NEW MEXICO OIL CONSERVATION DIVISION
 - Engineering Bureau -
 1220 South St. Francis Drive, Santa Fe, NM 87505

ADMINISTRATIVE APPLICATION CHECKLIST 30-015-05340

RE: Convert to Salt Water Disposal
Oil and Gas Department

From: Jones, William V., EMNRD
Sent: Friday, March 18, 2011 12:18 PM
To: 'Haynie, Carolyn (CHaynie) [Preferred Personnel]'
Cc: Ezeanyim, Richard, EMNRD; Warnell, Terry G, EMNRD; Dade, Randy, EMNRD; Reeves, Jacqueta, EMNRD
Subject: Disposal application from Chevron USA, Inc.: Skelly Unit #51 30-015-05348 9430 to 9650 Wolfcamp and Cisco

Skelly Unit #51 Wellbore Diagram (Current)

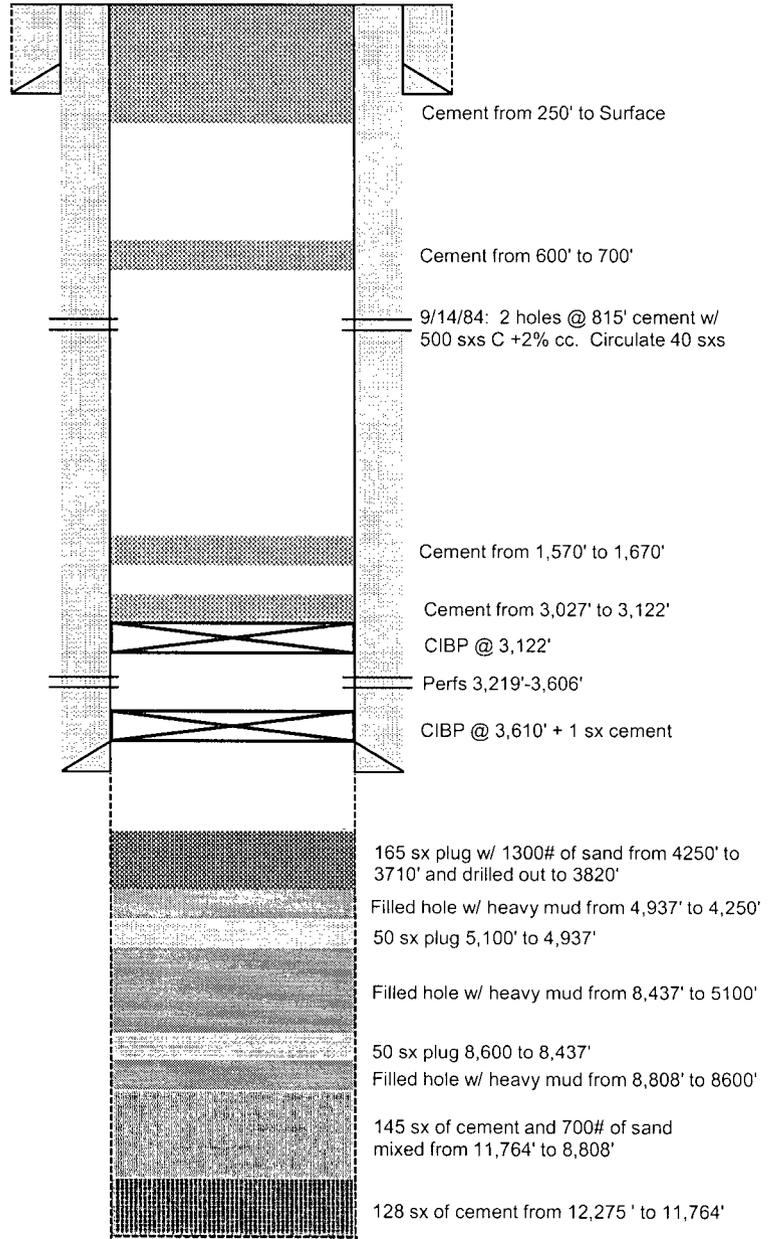
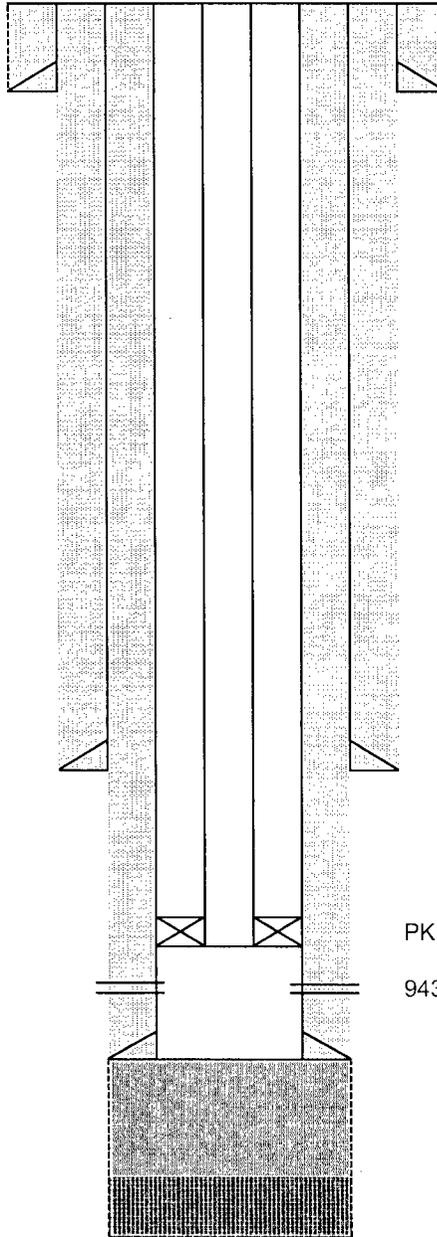
- a. Please ask your geologist what the top of the Penn formation is and send corrected wellbore diagrams. The diagrams show the top of the Penn at 10173 yet the application says disposal will be into the Cisco to a maximum depth of 9650. The Cisco is in the upper Penn, so something is missing (could be my understanding?) If the Cisco is the incorrect name on this application for the targeted disposal interval, then the application may need to be re-advertised.

- a. Please ask your geologist what the top of the Penn formation is and send corrected wellbore diagrams. The diagrams show the top of the Penn at 10173 yet the application says disposal will be into the Cisco to a maximum depth of 9650. The Cisco is in the upper Penn, so something is missing (could be my understanding?) If the Cisco is the incorrect name on this application for the targeted disposal interval, then the application may need to be re-advertised.
The top of the Pennsylvanian is the Cisco. The top of the Pennsylvanian is 9417'. Corrected wellbore diagrams are attached.

- e. Please add the proposed depth of the DV tool in the proposed 5-1/2 inch casing and add the cement data with designed cement tops above and below this DV tool.

- e. Please add the proposed depth of the DV tool in the proposed 5-1/2 inch casing and add the cement data with designed cement tops above and below this DV tool.

A DV tool will not be used for the proposed design. The 5 ½" production casing is designed to be cemented to surface.

Wellname: **SKELLY UNIT #950**

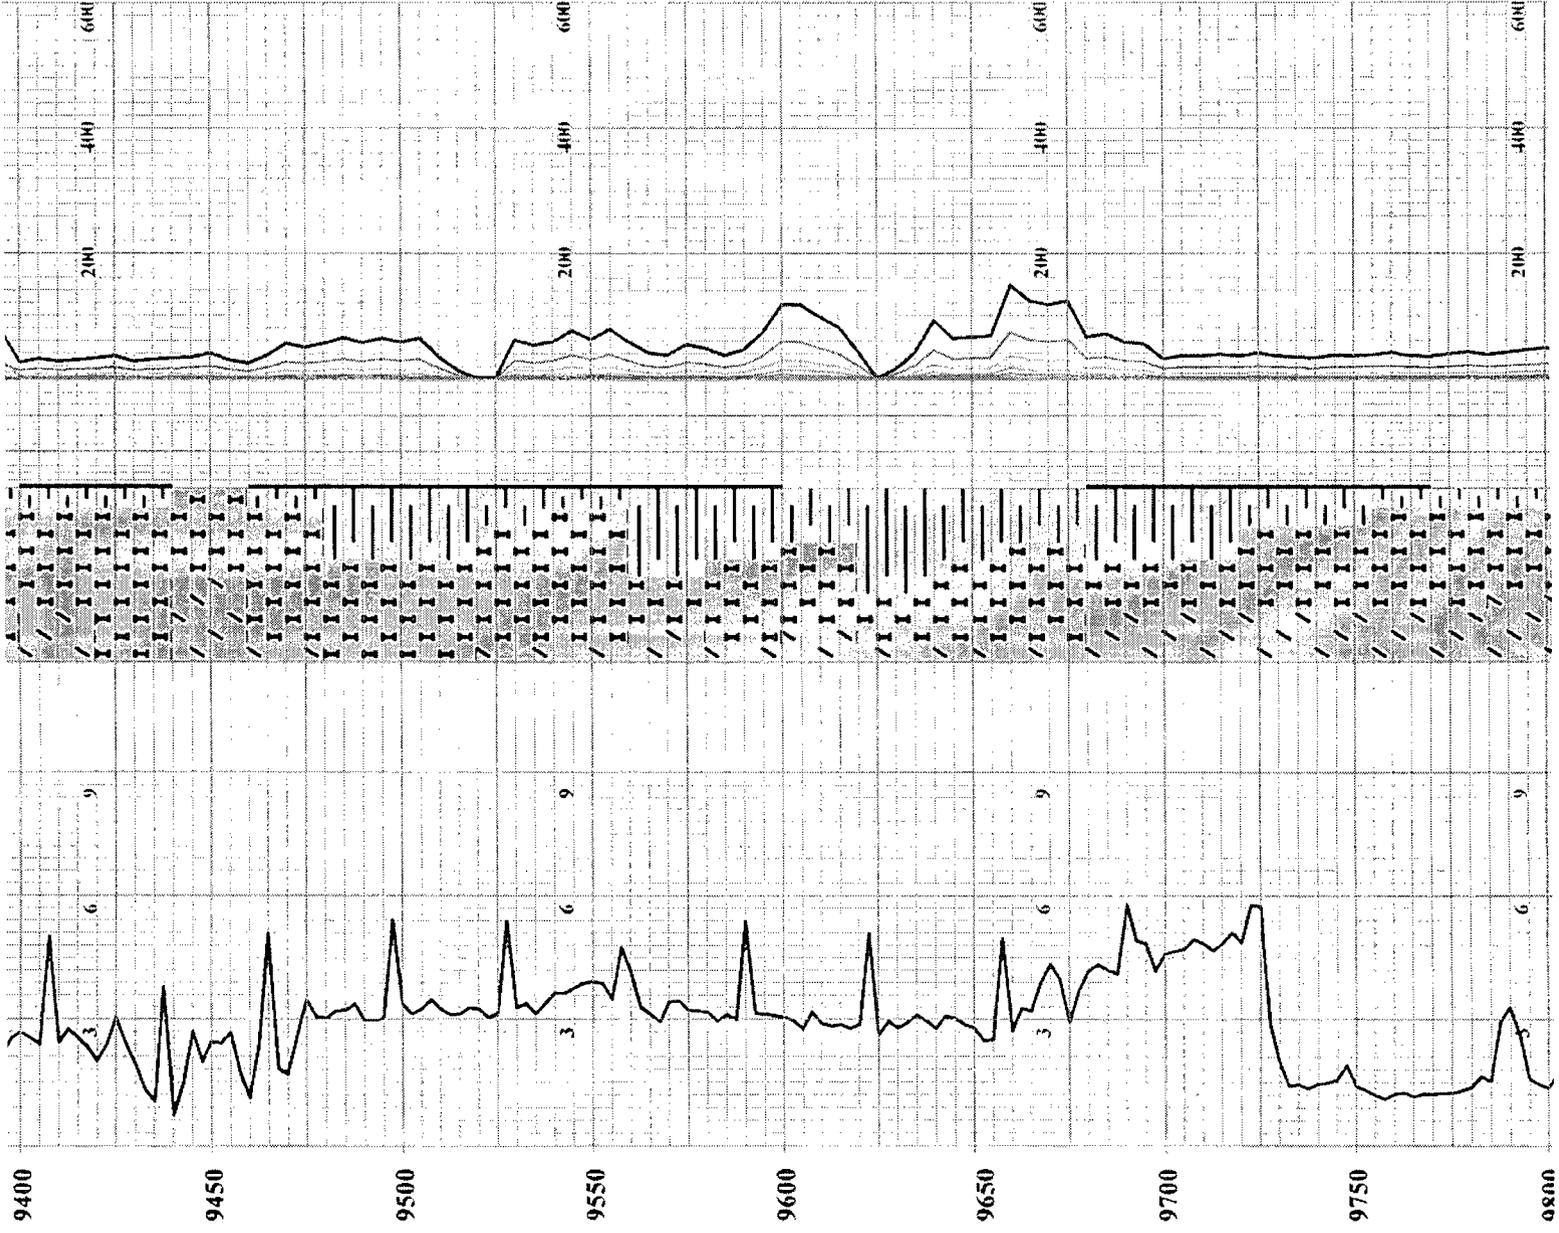
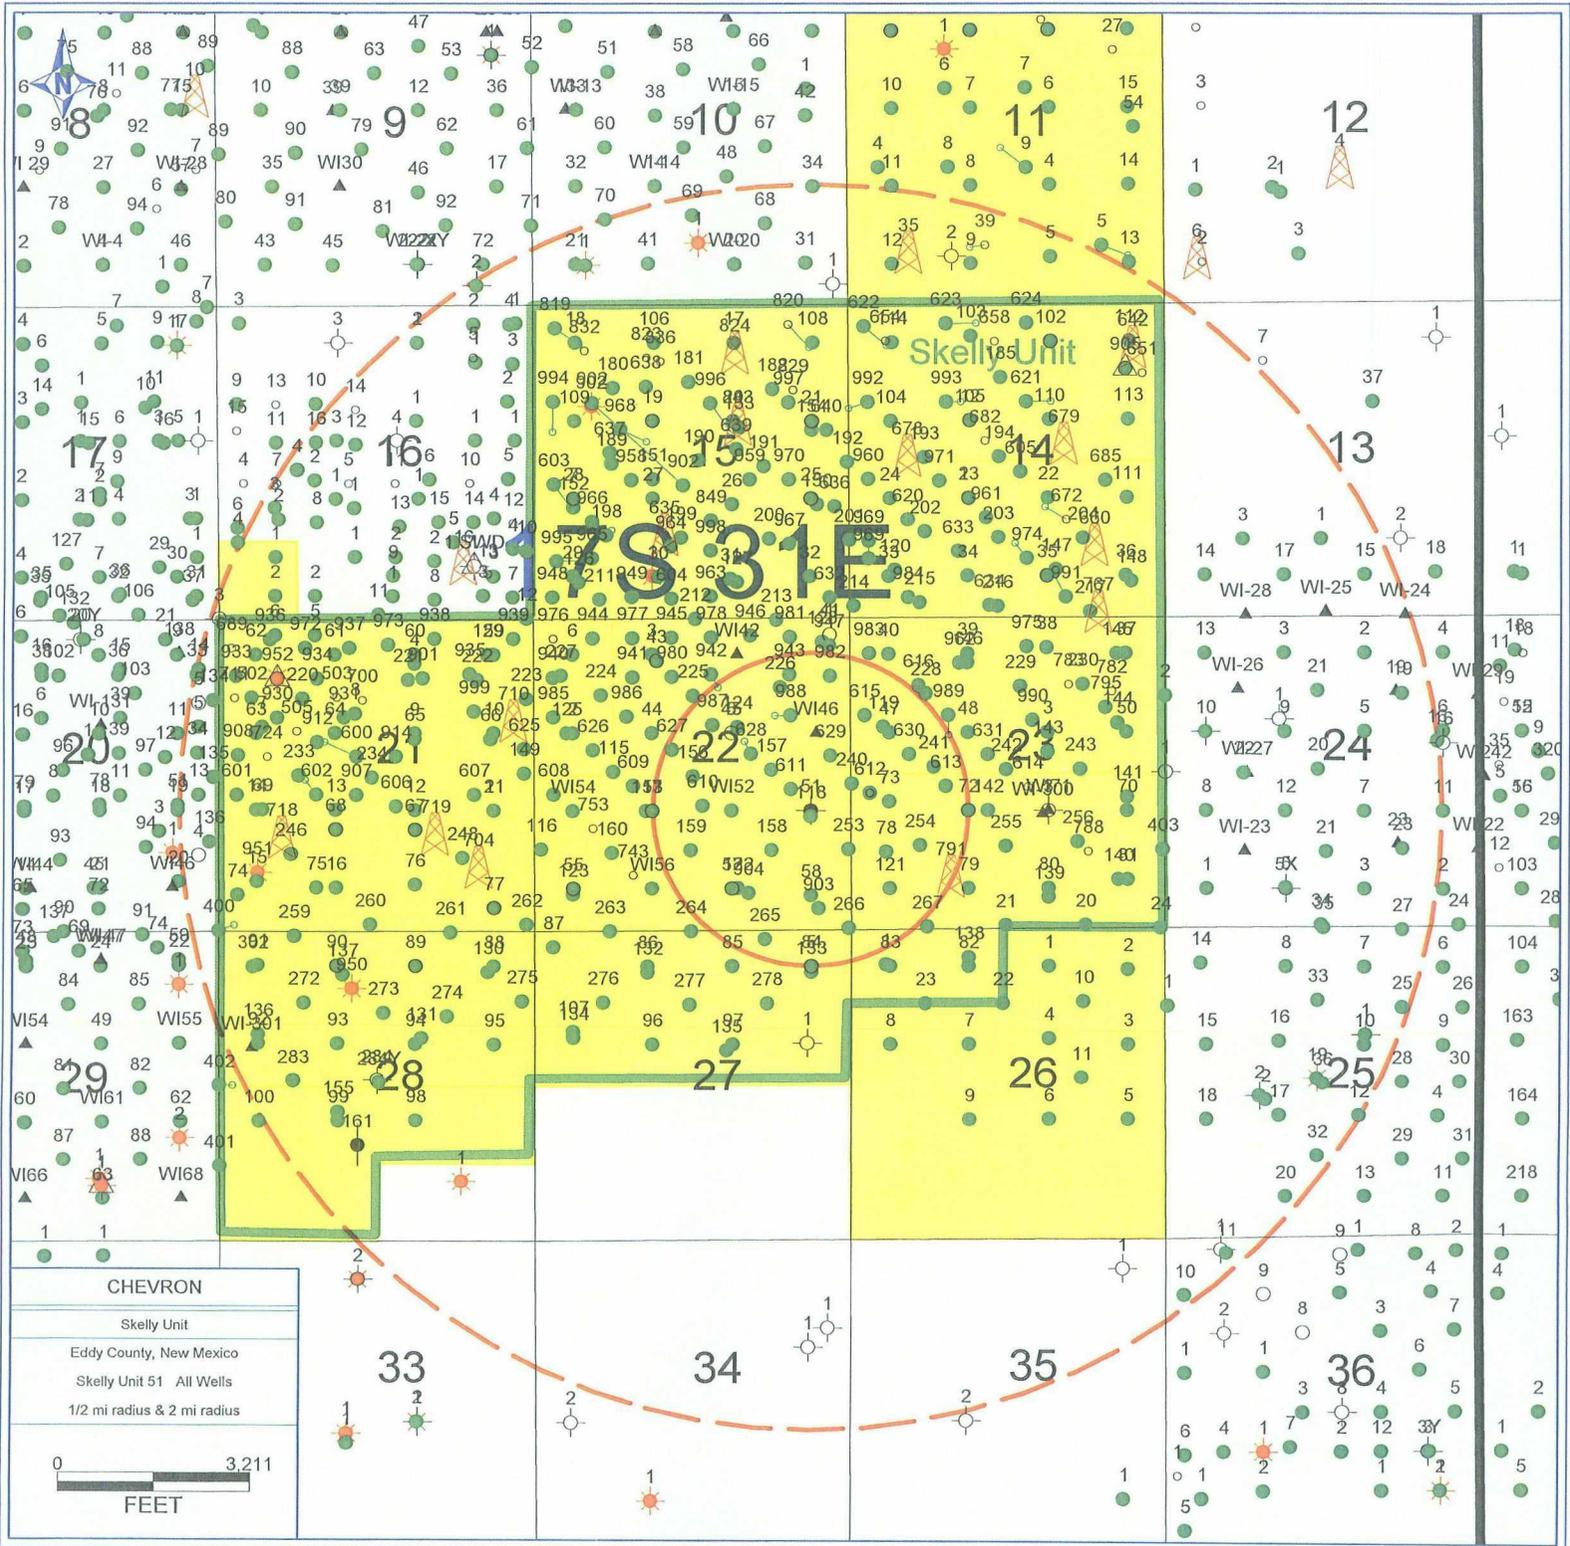
- d. Send a writeup, from a geologist or log analyst, as to the potential productivity of the proposed disposal interval (9430 to 9640). If you have any mudlogs through this interval, that would be good also. I am especially interested in the upper portion of the proposed disposal interval. If there is any question on productivity, Chevron will need to perf, treat, and swab test for hydrocarbons – especially the upper portion of this interval.

interested in the upper portion of the proposed disposal interval. If there is any question on productivity, Chevron will need to perf, treat, and swab test for hydrocarbons – especially the upper portion of this interval. The proposed interval (Cisco) has been known to have mud losses during the drilling of other wells in the area e.g. Skelly Unit 950 (30-015-32437), Skelly Unit 905 (30-015-31371), and Skelly Unit 902 (30-015-29322). There are mud logs present in other wells for the proposed interval which does not show any indication of hydrocarbon potential. The Skelly Unit 950 mud log is attached as a reference. Skelly Unit 51 does not currently have much data.
